Subject: Re: Planning Application No. A/NE-TKL/850 --- Proposed Temporary Warehouse for Storage of Construction Materials/Tools and Equipment with Ancillary Office/Workshop and Associated Filling of Land for a Period of 3 Years

Responses to Comments of Planning Department and DEVB

Application No. A/NE-TKL/850

Plan 8

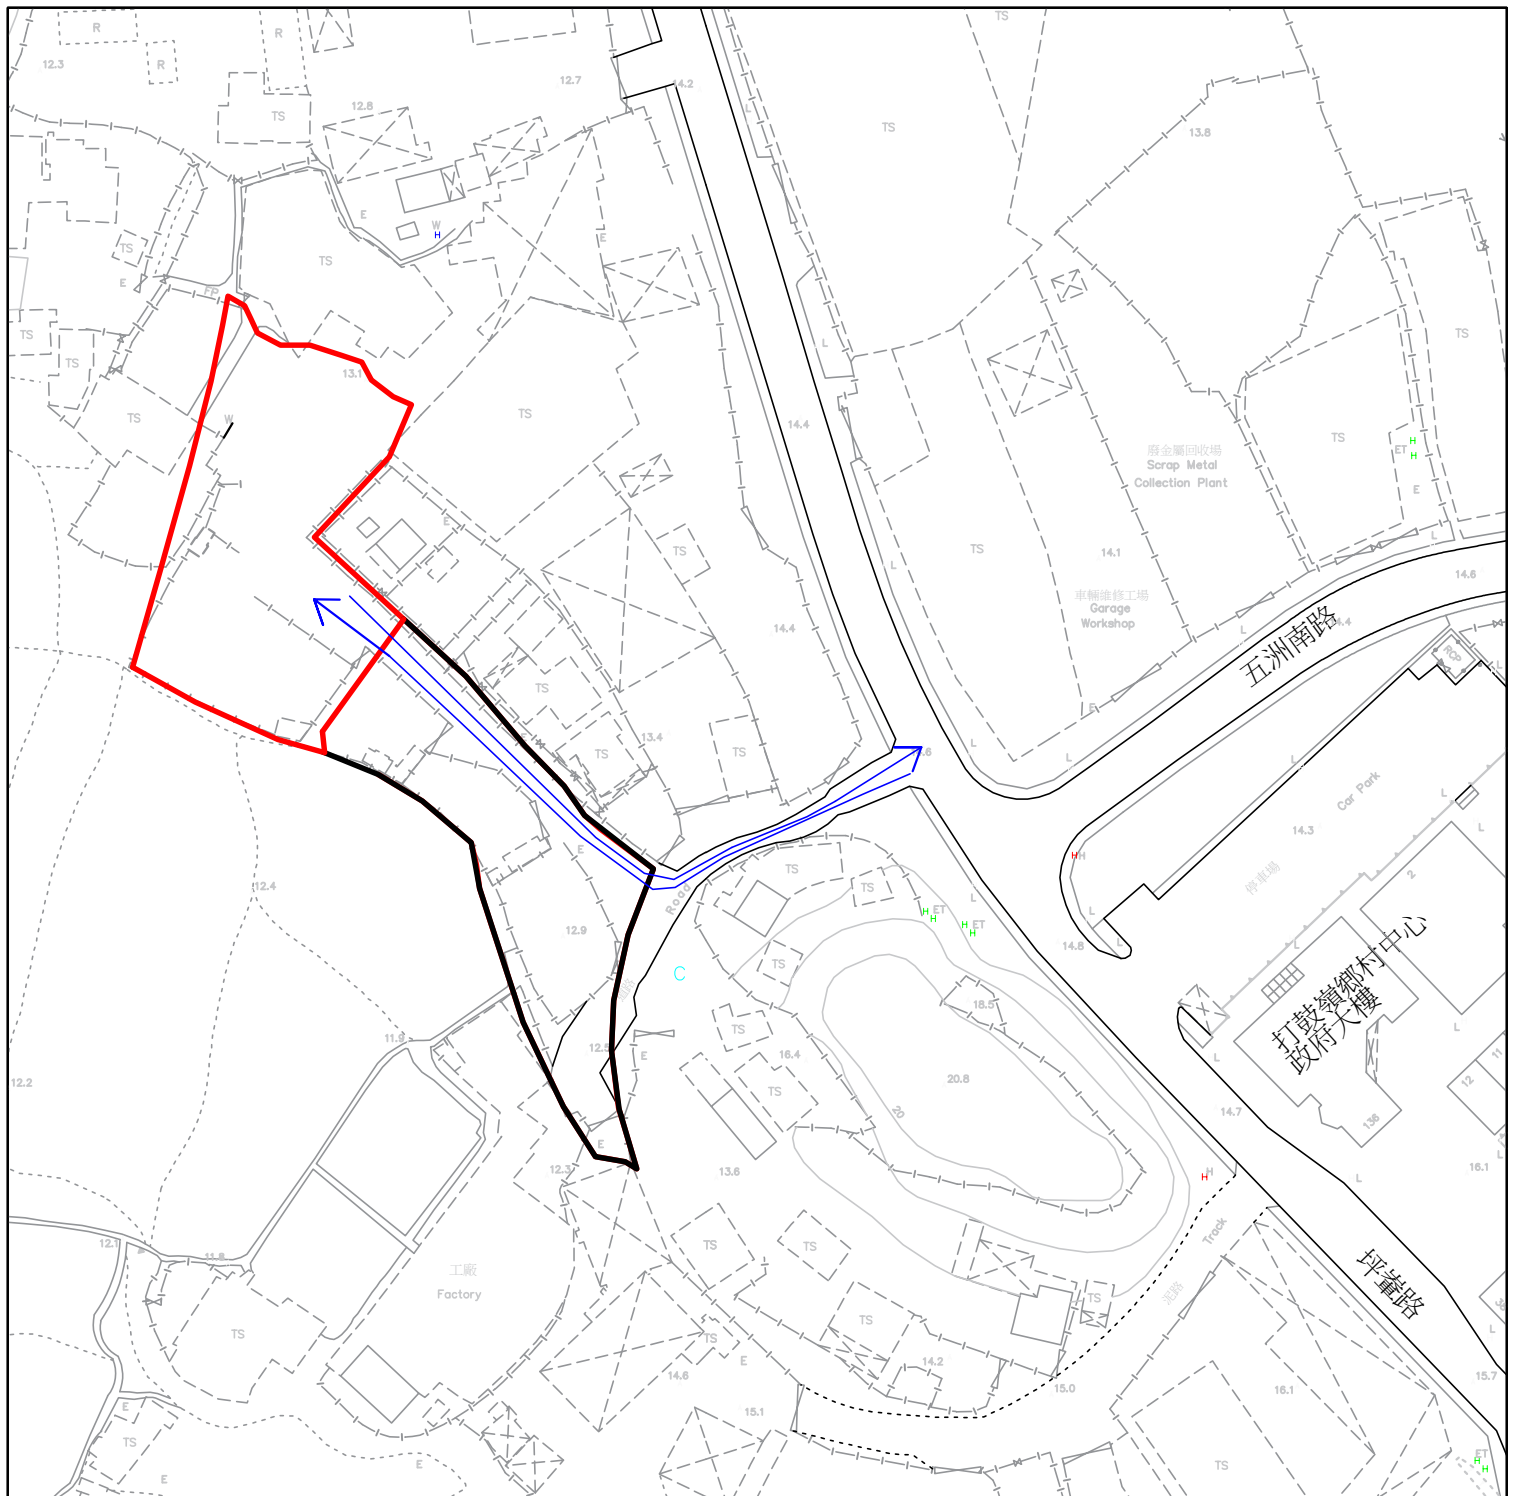
Planning Department's Comments 1. Please show the access route to the Site from Ping Che Road on Plan 2. According to our site inspection, there is/are tree(s) along the western boundary of the application Site. Please clarify if any tree felling will be involved in the application. If yes, please also supplement the species of tree, 3. As mentioned in the Planning Statement, the Site is currently entirely hard paved. Please clarify if the area along the western boundary, especially the northwestern corner, of the application site is currently hard-paved as well. If Not, the applicant	1. The access route to the Site from Ping Che Road is shown on attached Plan 8 2. Please see revised Plan 7 as attached showing the portion of land which is not filled at the moment. There are common species of trees located at this area including Lychee Tree, Wampee tree, and mango trees which will be removed and the said portion of land will be land filled. 3. The north-western portion of the site as shown on revised Plan 7 is not land filled at the moment.

Plan 7

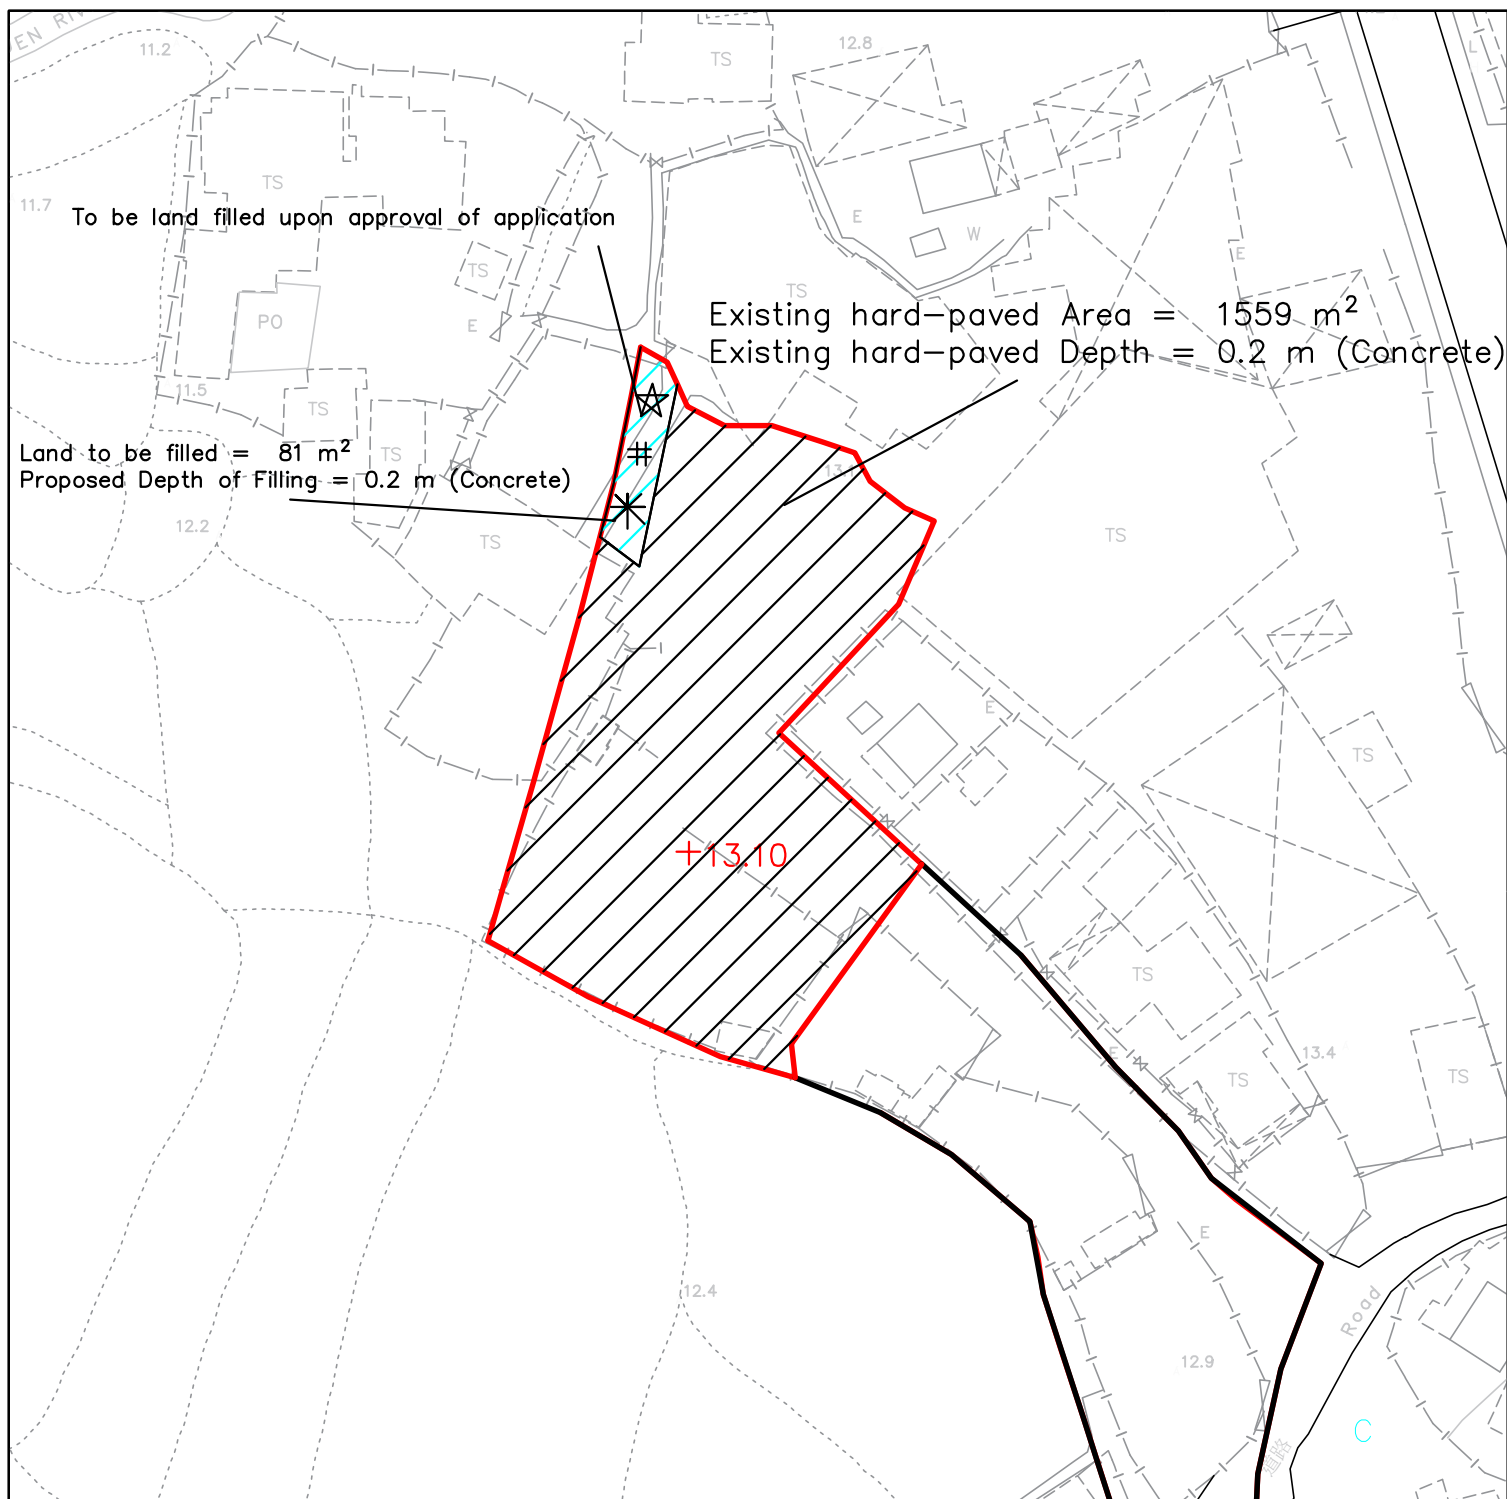
should apply for regularization of filling of land at part of the application site and further land filling at the remaining portion of the application Site. An updated filling of land Plan will be required.

The area of land to be filled is shown on the attached revised Plan 7. The hard-paved land within the Site is to be applied for regularization under this application.
